SUNDRY NOTICES AND REPORTS ON WELLS

DUNN 2E

BASIN DAKOTA

On October 1, 1993, BCO, INC. recieved verbal approval from Wayne Townsend, to recomplete the Dunn 2E and to build a pit of suitable size within the pad area to allow for the recompletion. The well is to be recompleted as follows:

# DIAGRAMMATIC WELL SKETCH

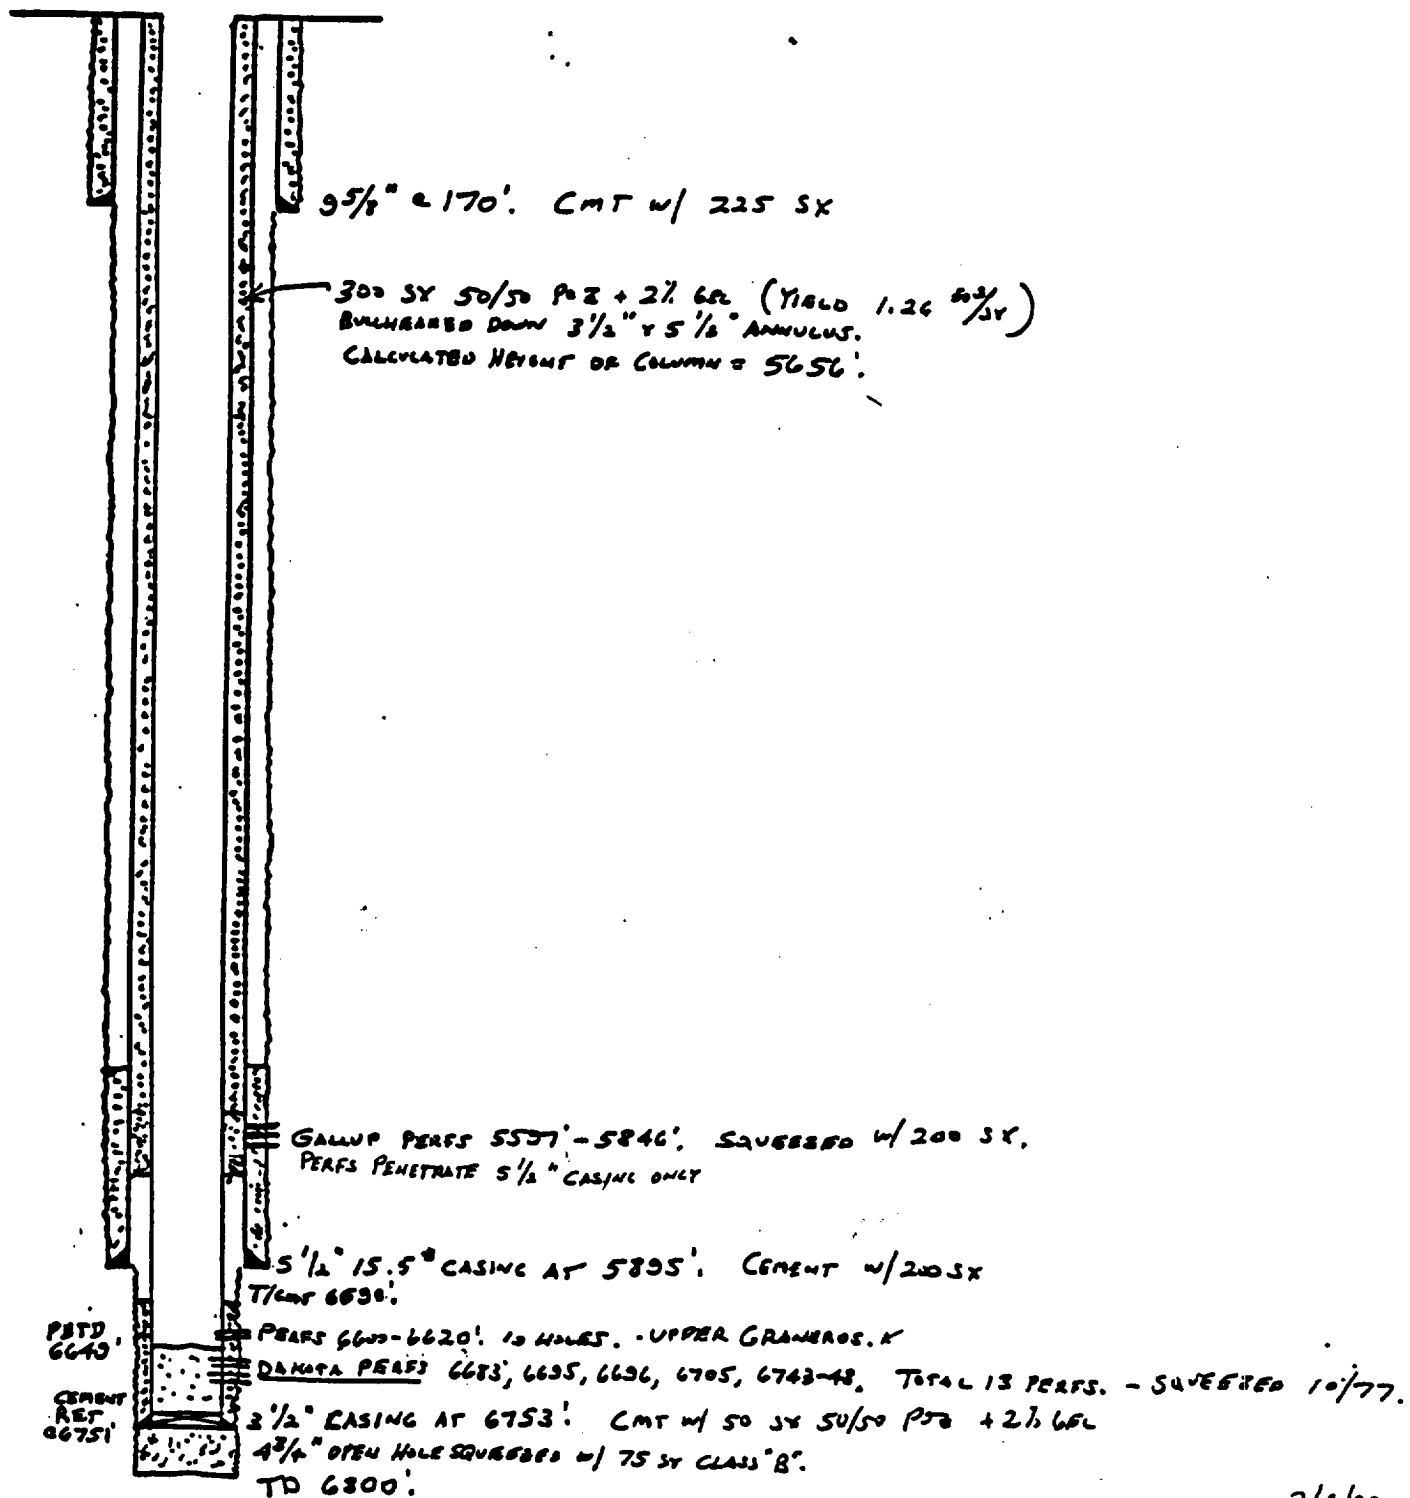
- 1) A cement retainer will be set at 6016' and 30 sx of classs "B" Neat cement will be squeezed into the existing perfs from 6600' to 6620'
- 2) Squeeze holes will be shot at 5840', 5900', 5914', 5816', a cement retainer will be set at 5826' and 50 sx of class "B" neat cement will be squeezed into these holes
- 3) The Gallup formation will be perforated from approximately 5612' to 5739', acid stimulated and hydraulic fractured
